SUBJECT: MANAGEMENT ORGANIZATION

Re: Nine Mile Point Nuclear Station, Unit No. 1

Amendment No. 77
License No. DPR-63

SAFETY EVALUATION BY THE OFFICE OF NUCLEAR REACTOR REGULATION
SUPPORTING AMENDMENT NO. 77 TO FACILITY OPERATING LICENSE NO. DPR-63

FIGURE 6.2-1

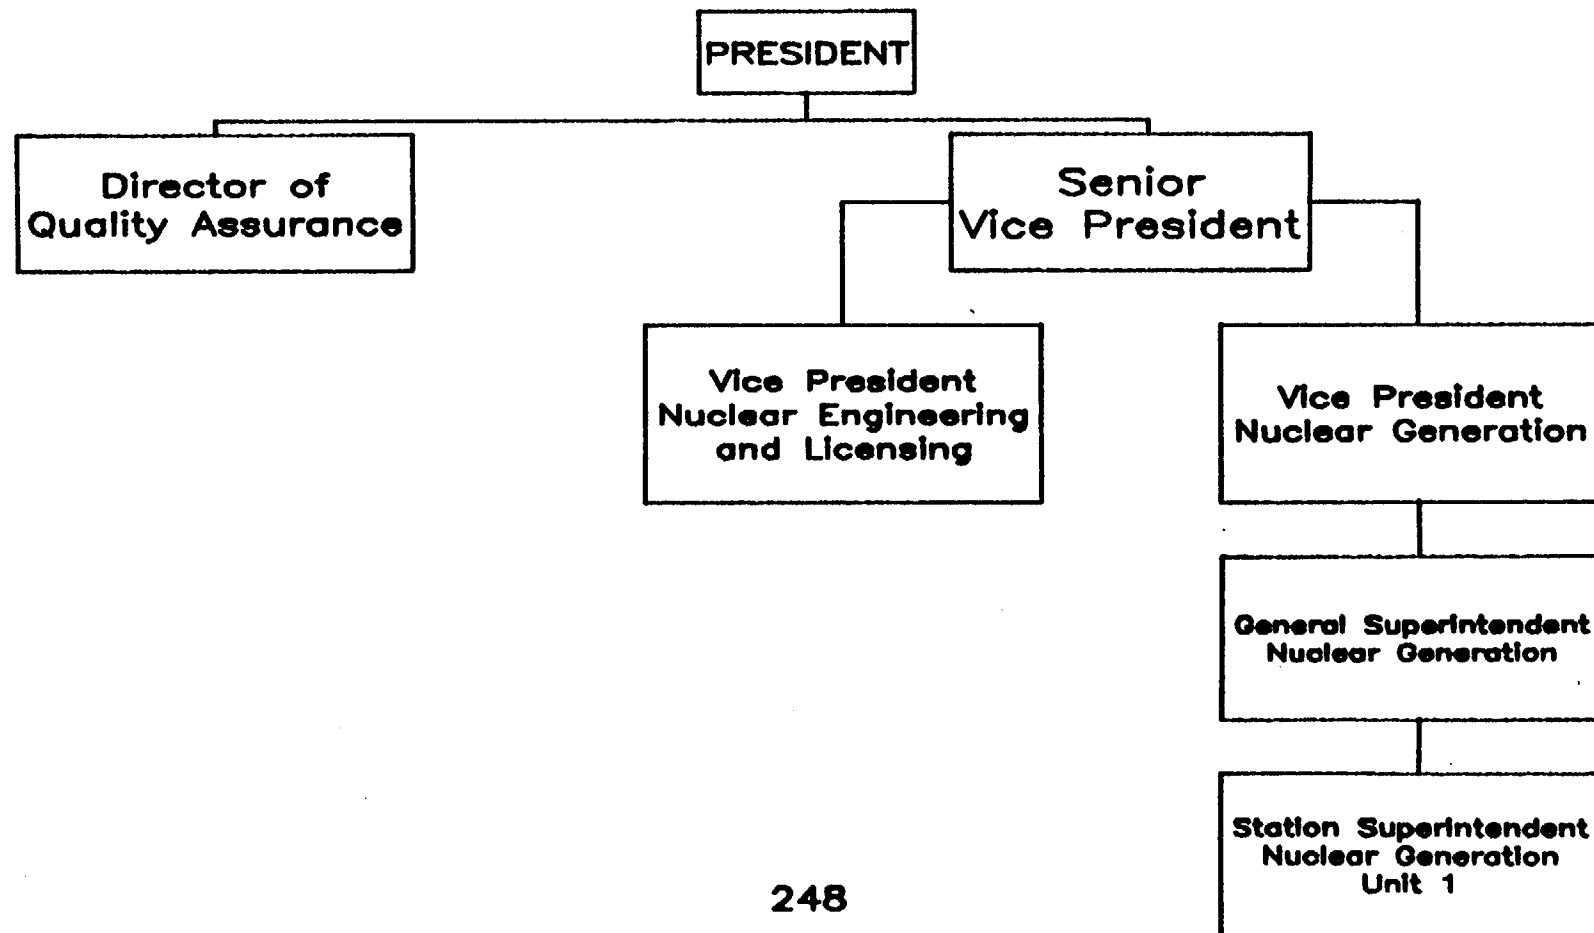
The amendment revises the Technical Specifications by changing Figure 6.2.1 to reflect a change in the management organization at Niagara Mohawk Power Corporation (NMPC).

The proposed change to the TS requested by the licensee reflects a change to the management organization at NMPC. Figure 6.2.1 has been changed to show that the duties and authority of the Executive Director of Nuclear Operations have been assumed by the Senior Vice President as a result of an action by the Board of Directors of the Niagara Mohawk Corporation. In the new organization the Senior Vice President is responsible for all aspects of nuclear engineering, nuclear licensing and operation at the Nine Mile Point Nuclear Station, Unit No. 1.

The change proposed in the application presented by the licensee restores the organization to a form that is essentially the same as the one which was utilized to operate the facility prior to the inception of the position of Executive Director of Nuclear Operations. The organization that is being proposed by the licensee is virtually the same as one that has been previously approved by the Staff. Further, the licensee has demonstrated that the proposed organization is a suitable one for facility operation by virtue of its successful operation of the facility with a very similar one in the past. In addition, the licensee has demonstrated that Mr. C. V. Mangan is highly qualified and has the requisite skills and knowledge to ensure safe continued operation of the facility. Therefore, we find the proposed change acceptable.
